ERRATA

Illinois Route 47 (Reed Road to U.S. Route 14) McHenry County, Illinois

Job No. P-91-101-07

August 10, 2016

\\uschi1fs001\prod\Projects\P60039027\000_CAD\006_Civil\Env\Sheets\39027_SHT_ENV_Constraints14.dgn
7/8/2016

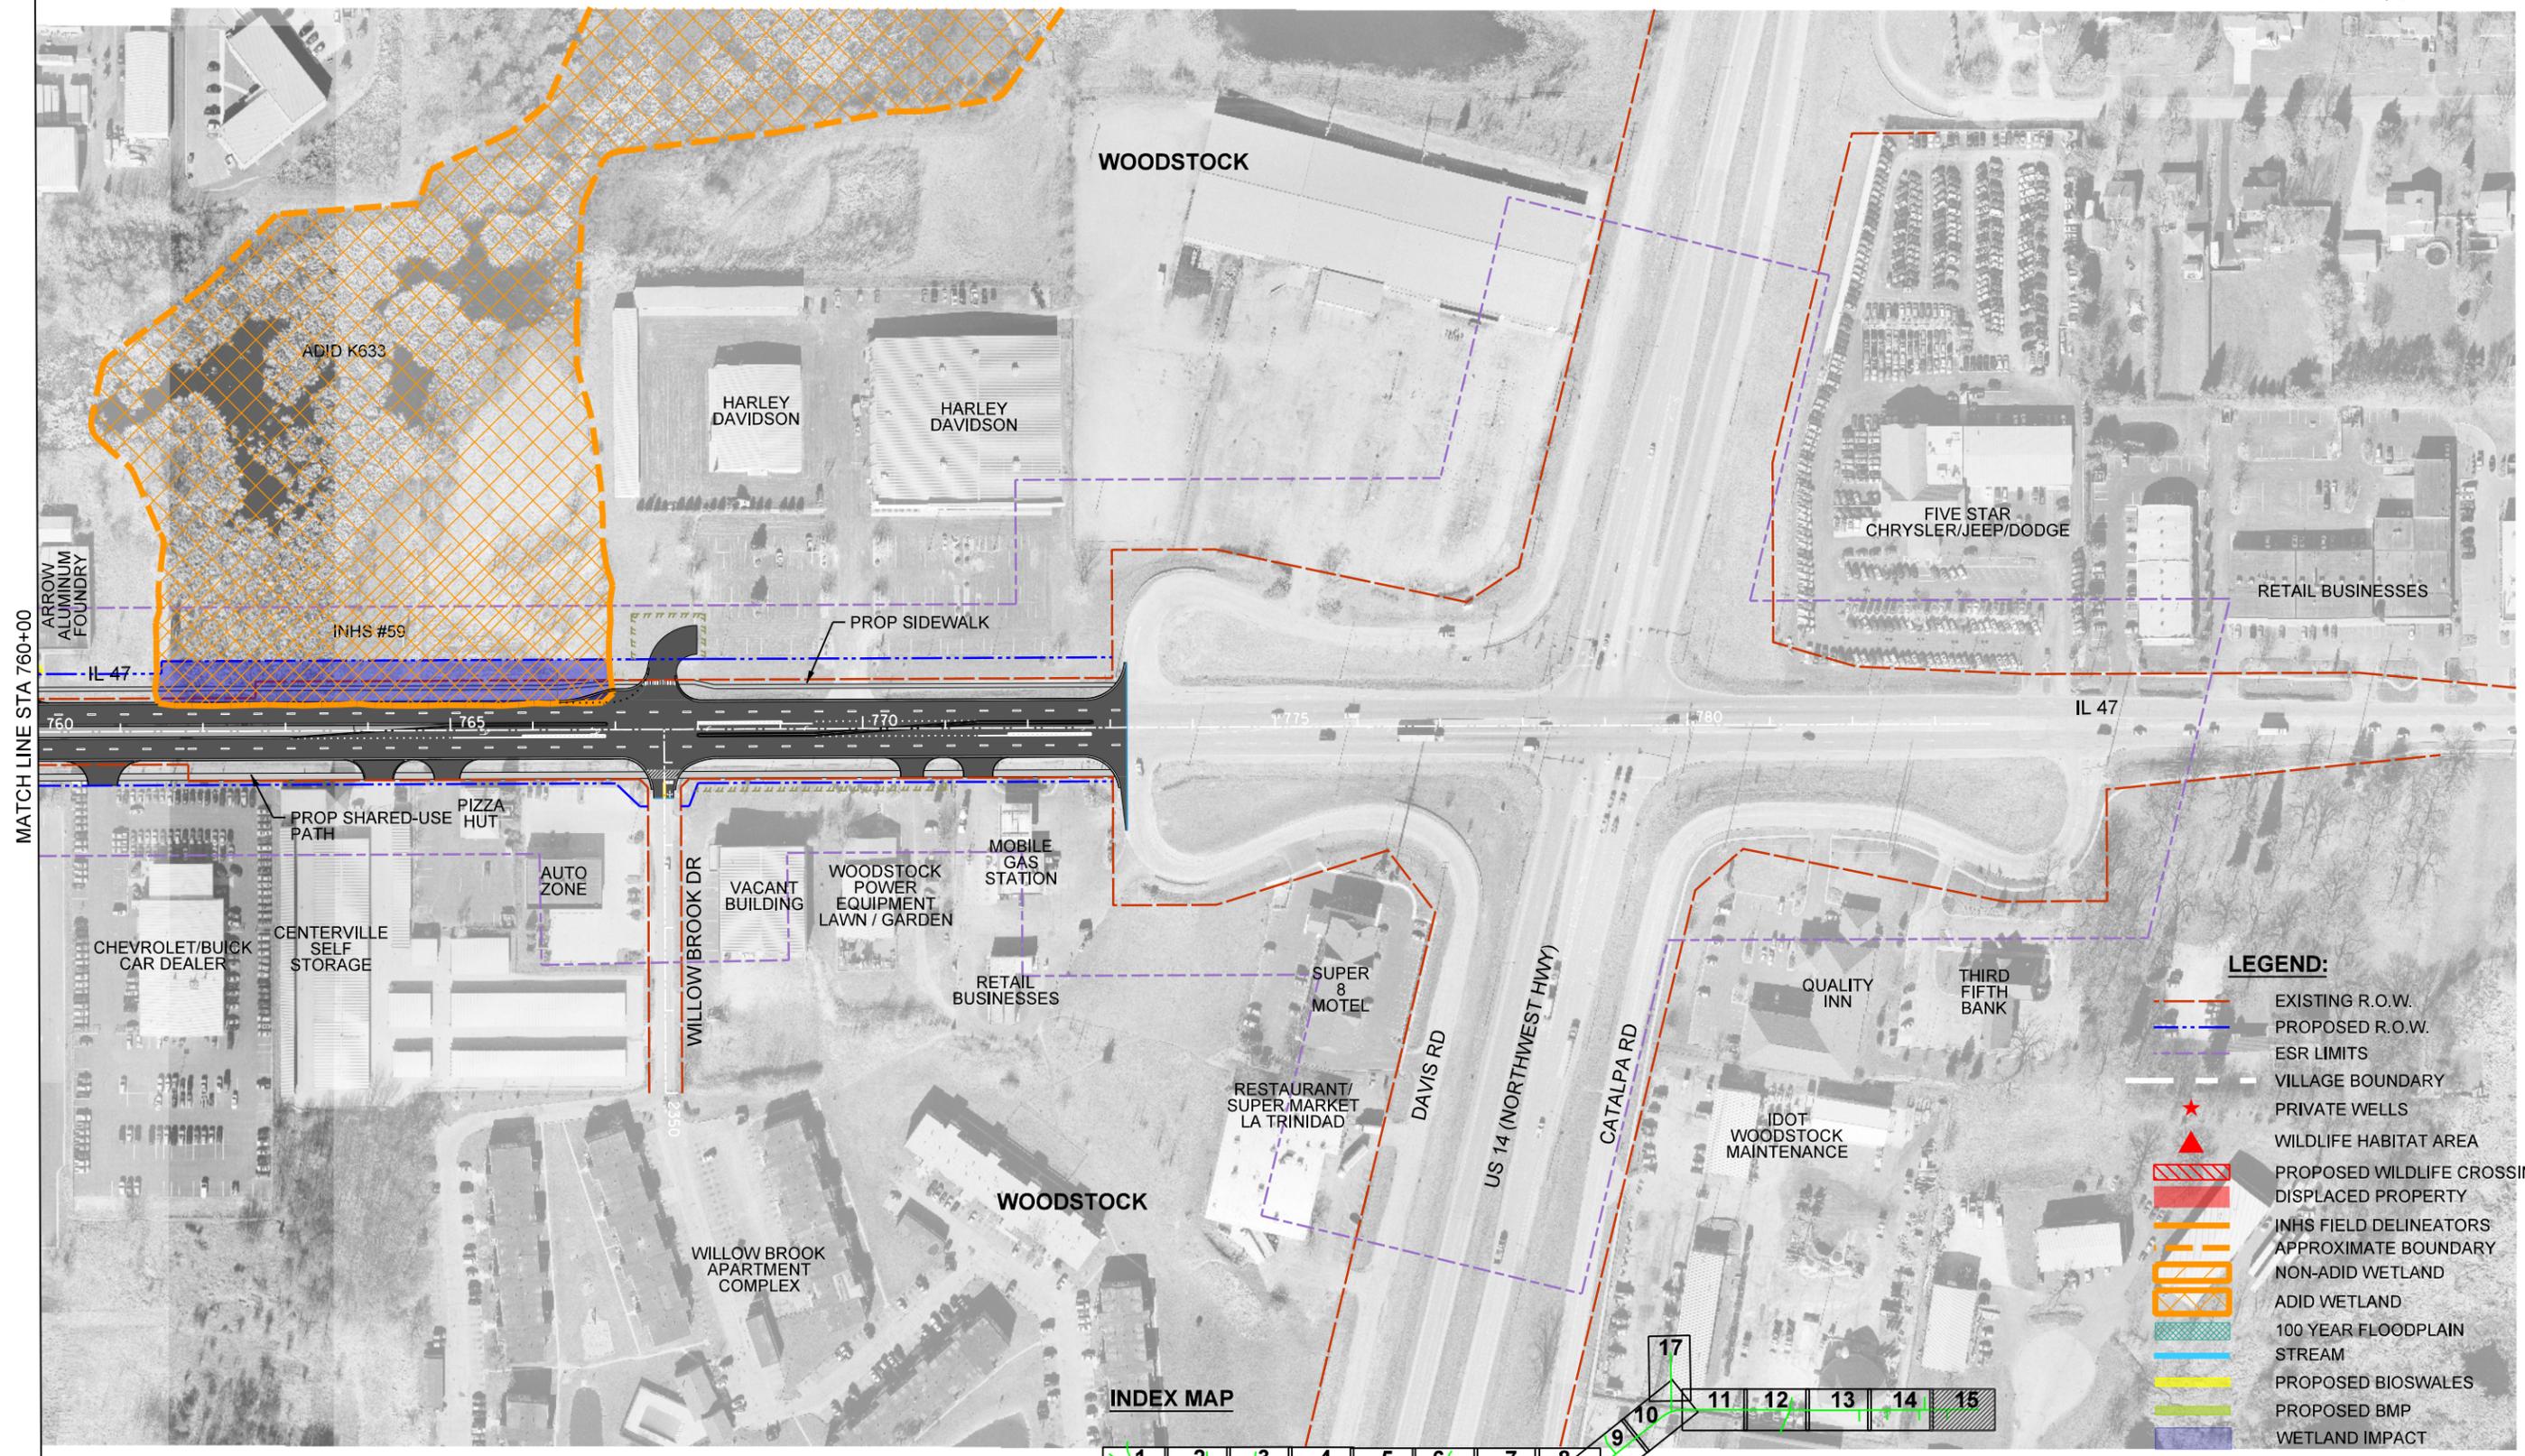
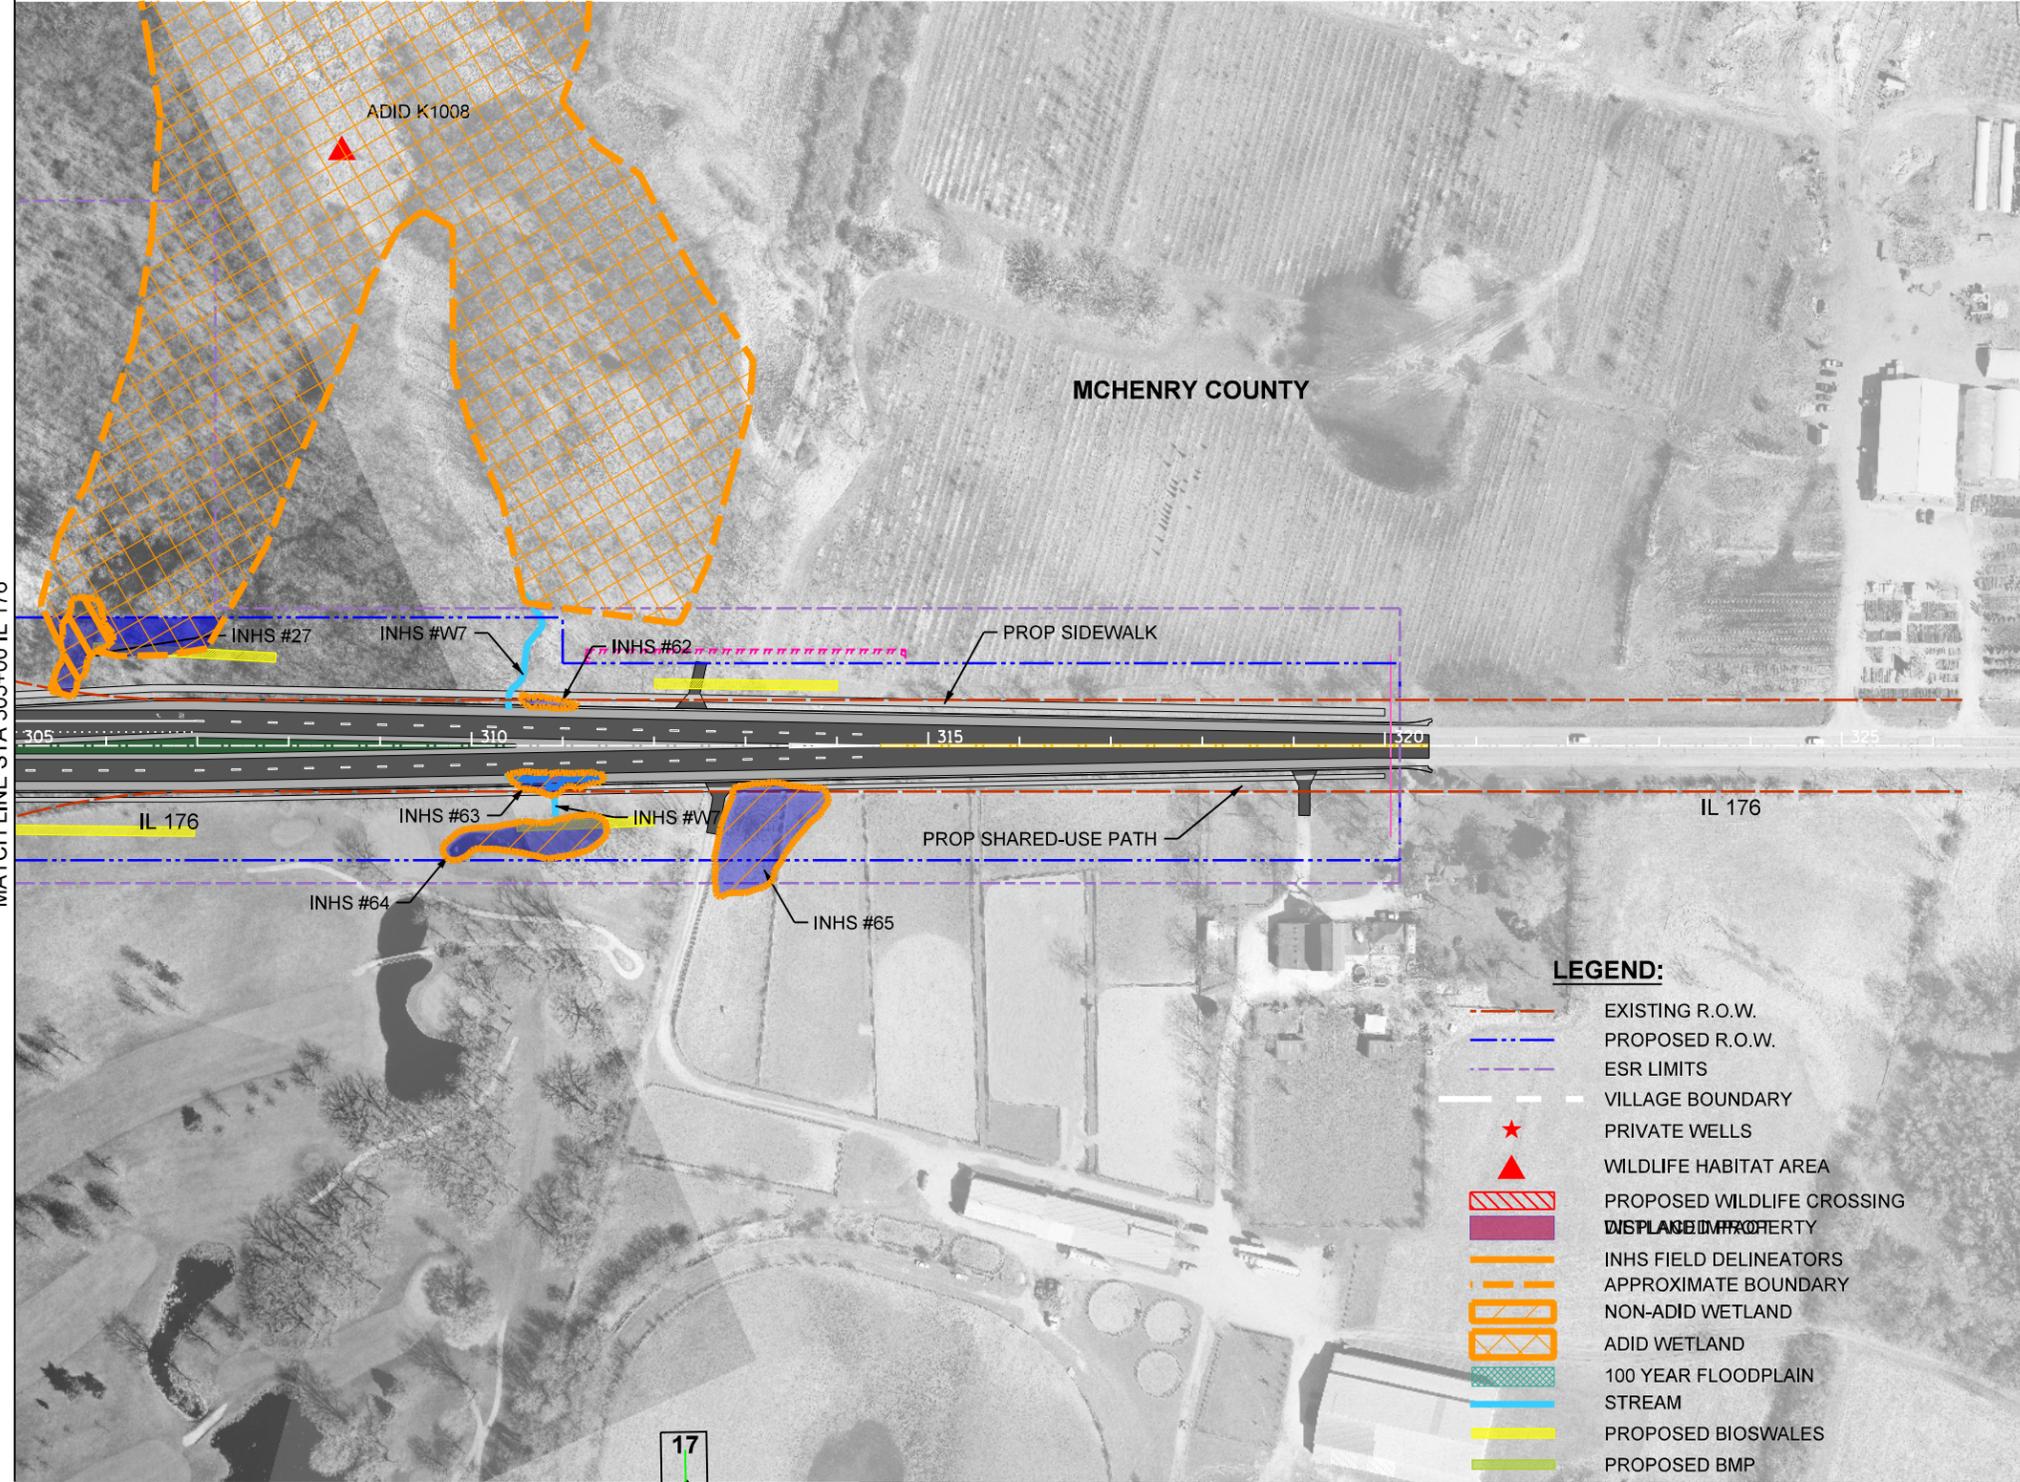
Replace Exhibit 4-1 Environmental Constraints Map to show updates to waterway names to be consistent with the Environmental Assessment, revised symbolization of the bioswales and inclusion of additional BMPs.

R	<p>A revised exhibit with a non-conflicting color scheme has been included in the Errata.</p>
87	U.S. Army Corps of Engineers	C	<p>The bioswale locations in Exhibit 4-1 should not be located within delineated wetlands or streams. Exhibit 4-1 should be revised accordingly for the final EA;</p>
		R	<p>The exhibit has been revised showing potential new locations as necessary. However, since the wetland impacts were considered to be everything within the ROW, those areas are proposed ditch locations where BMPs or bioswales are proposed; there may no longer be a functioning wetland due to construction disturbance. The design engineers will consider where regrading for the roadway and ditch work will take place while minimizing any impacts. However, there will be situations where the wetland will be graded out as part of the roadway and/or ditch construction, but these locations may be replaced with a bioswale.</p>
